**CERTIFICATE OF APPROPRIATENESS**

**Property:** 4009 Pineridge Street, Lot 13, Block 125, North Norhill Subdivision. The property includes a historic 916 square foot, one-story wood frame single-family residence and historic one-story detached garage situated on a 5,000 square foot (50' x 100') interior lot.

**Proposal:** Alteration – Revision. Construct an approximately 900 square foot one-story rear addition. The addition will begin at the existing rear wall, have a ridge height lower than existing, and will be clearly delineated from the historic structure.

**WEST (REAR) ELEVATION**

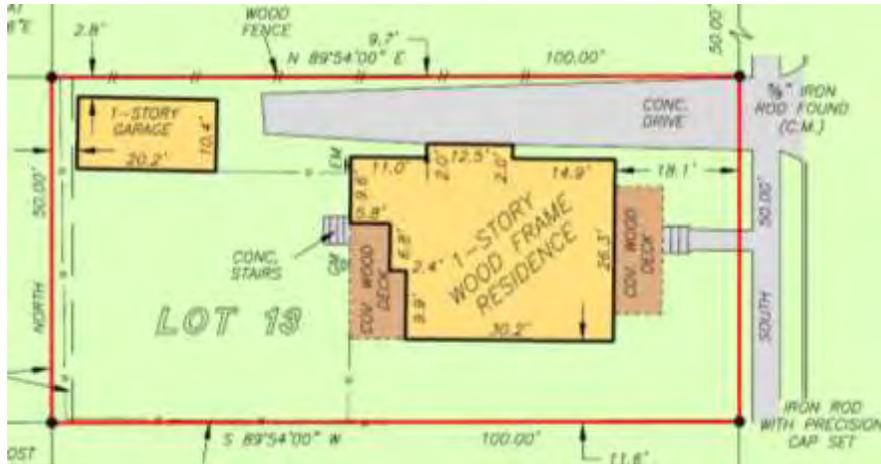
- Remove two (3X5) windows from the Northern Wall of addition
- Install two windows on the west (rear) elevation of the addition, flanking the door
- Removed ribbon window from the south elevation of addition.
- Raise ribbon window on the south elevation of the addition
- Change double windows on the south elevation of the addition to a single ribbon window
- Add window to east elevation of addition.
- Moved location of addition 1'-6" to the south to ensure room for a single car garage as previous site plan was incorrect
- Removed shiplap siding from interior of historic home and request approval to add shiplap replacement material: 4'x12' sheets of 5/8" sheetrock.

Incorrect Site Plan (Submitted 12/17/2017)

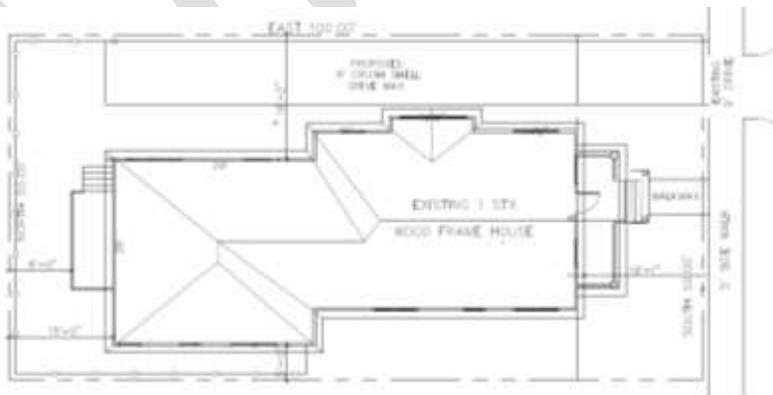
Corrected Site Plan

The addition will begin at the rear wall of the existing structure and have a north side setback of 16'-2"; a south side setback of 5'-10"; and a rear (west) setback of 8'-0" (to deck) 15'-0" to the rear wall of the addition. See drawings for more detail.

FIRST FLOOR PLAN

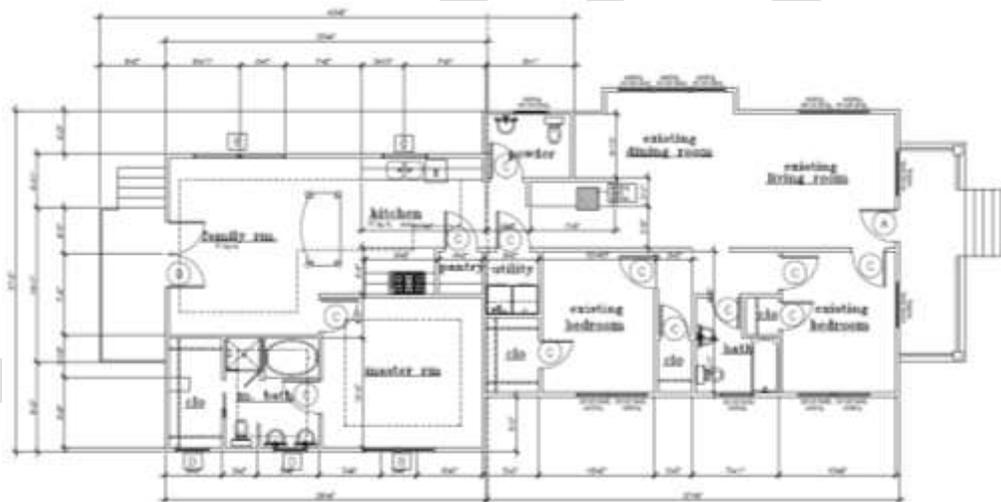
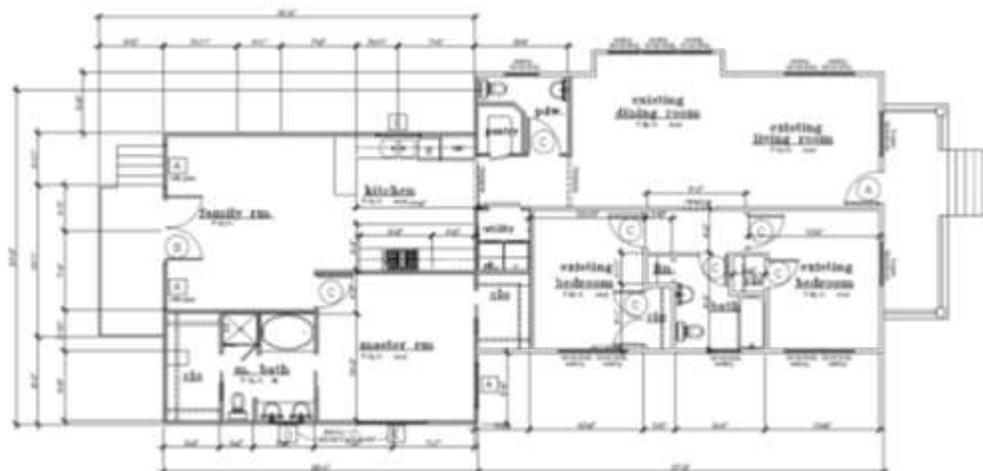
In the revised proposal the addition will be shifted 1'-6" to the south. The addition will extend 6'-8" out to the south and will be inset 5'-6" on the north. The addition will extend 29'-4" towards the rear. The proposed addition will have a ridge height of 19'-0". See drawings for more detail.

ROOF PLAN

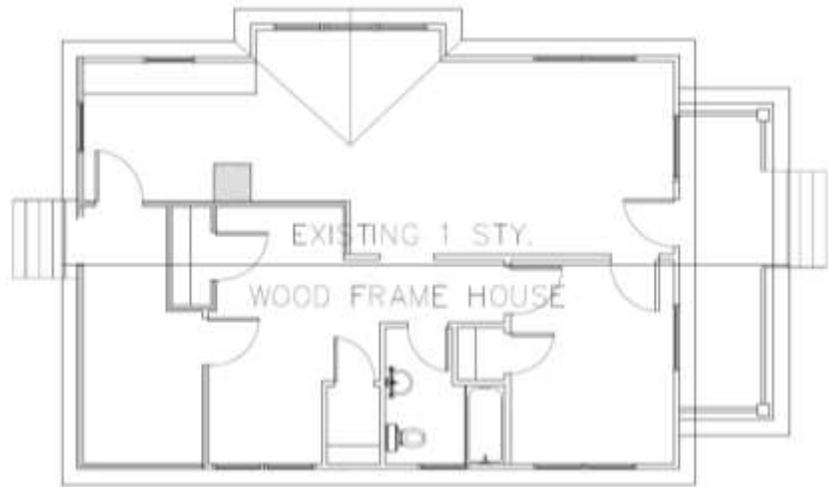
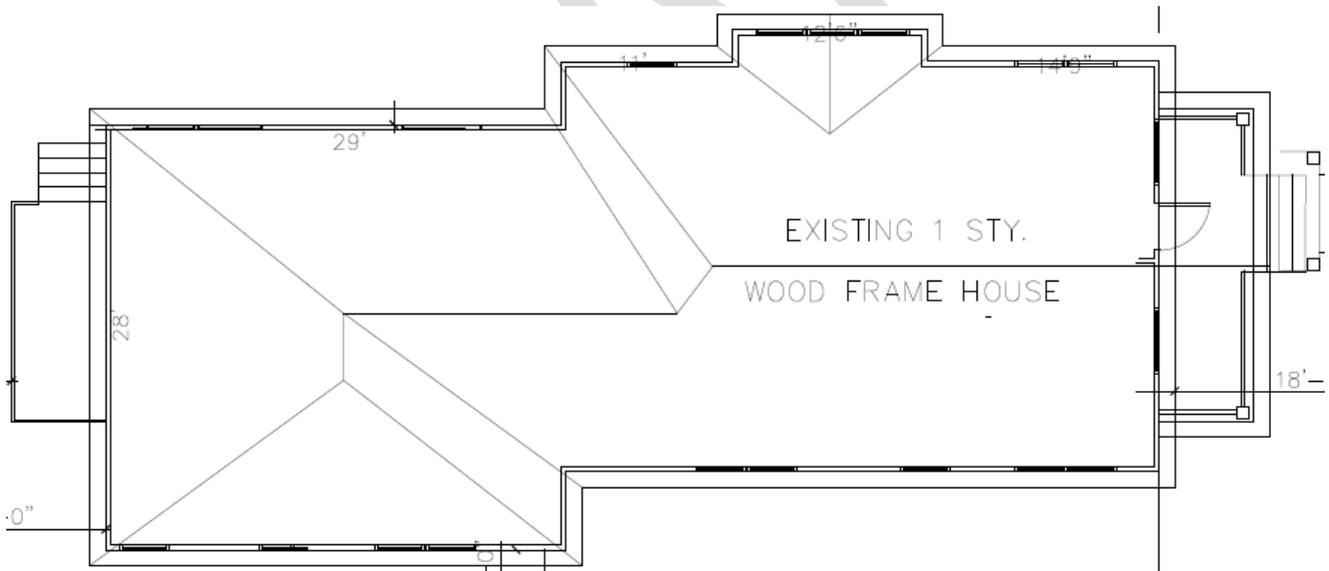
The proposed addition will have a hipped composition shingle roof with a pitch of 7:12 that will tie into the rear of the existing roof. The proposed eave height will match existing at 11'-6" and the eave overhang will match existing at 12". See drawings for more detail.
